ADDENDUM

BUSHBABY ASSEMBLY

MANUAL

FUSELAGE MANUAL

PART F3

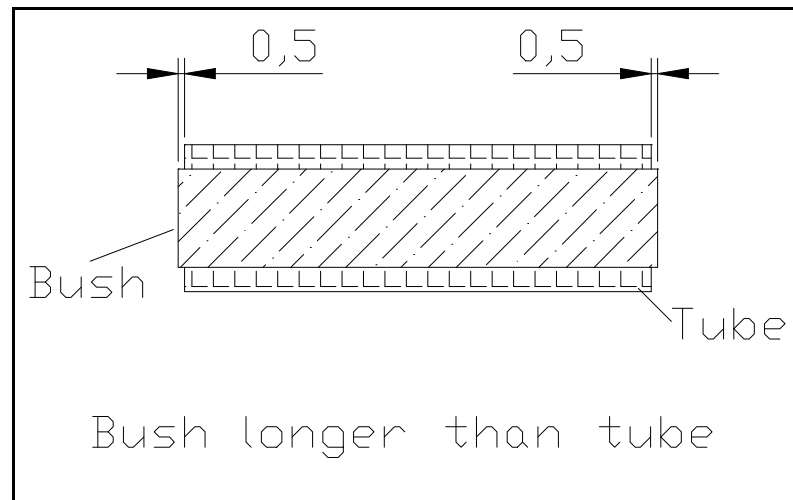
Bronze bush installation

NOTE:	The part must pivot around the Bronze Bush i.e. The bolt must remain stationary
-------	---

1.4 SEAT BELT MOUNTING TABS

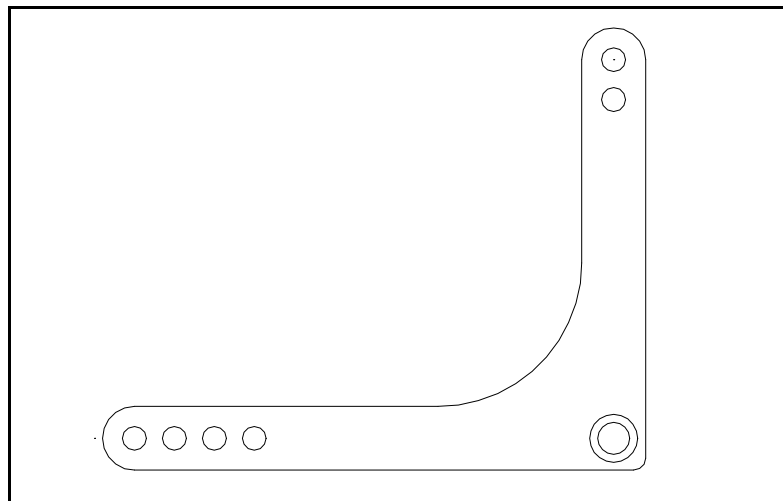
All seat belt and harness tabs are pre drilled. There are now only two shoulder harness tabs instead of three.

FBC-1

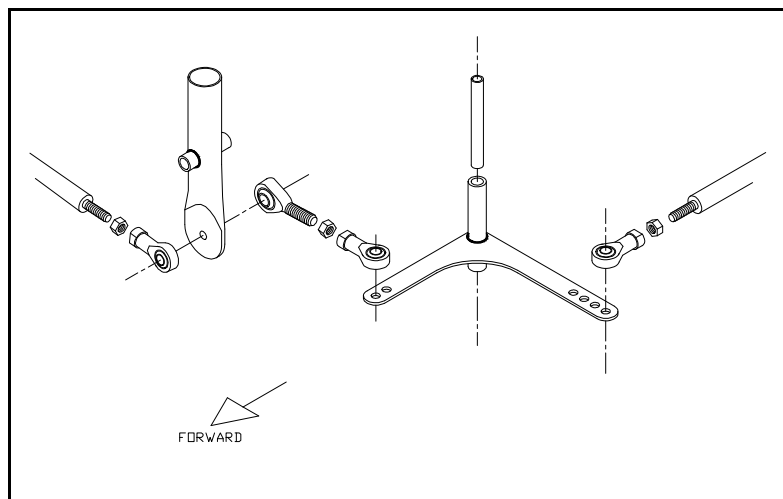
The FBC-1 bell crank has change slightly, now that it is laser cut

PAGE F11

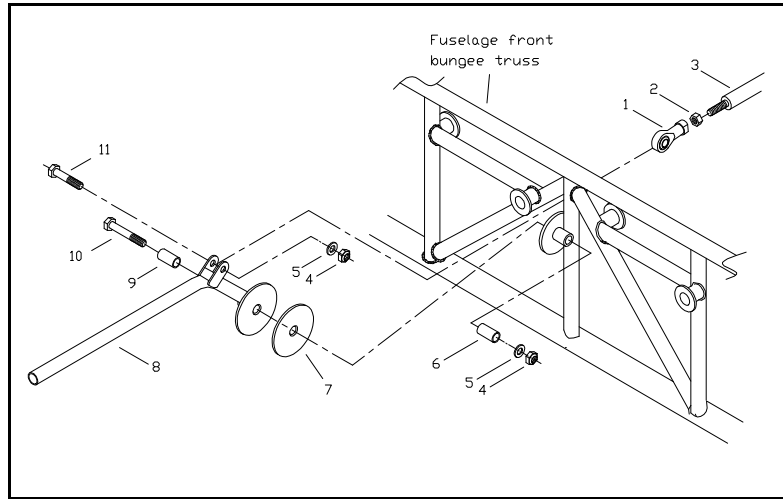
6. The FCT-7 is not 16mm but \varnothing 25mm aluminium. The 6mm rod-end is screwed in as far as possible

The rod-end installed in the FCT-8 fitting is not to be used as an adjuster. If the rod end is not screwed in fully, it could pull out of the aluminium fitting under severe pressure.

FBM- A & FBM-B ASSEMBLY

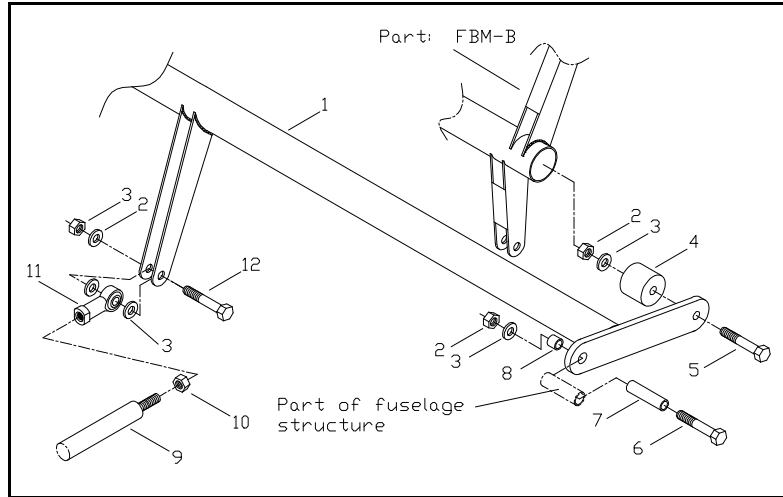
1. Part FRB-4 should read FBR-4

PAGE F14/15

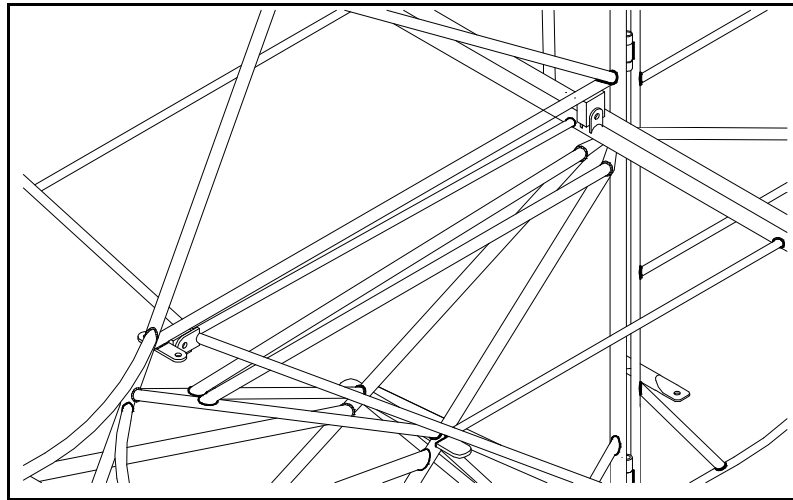
2. Sketch: the bolts holding the stabilizer to the frame now fit from left to right, not front to rear as shown in sketch. Bolts are now longer.
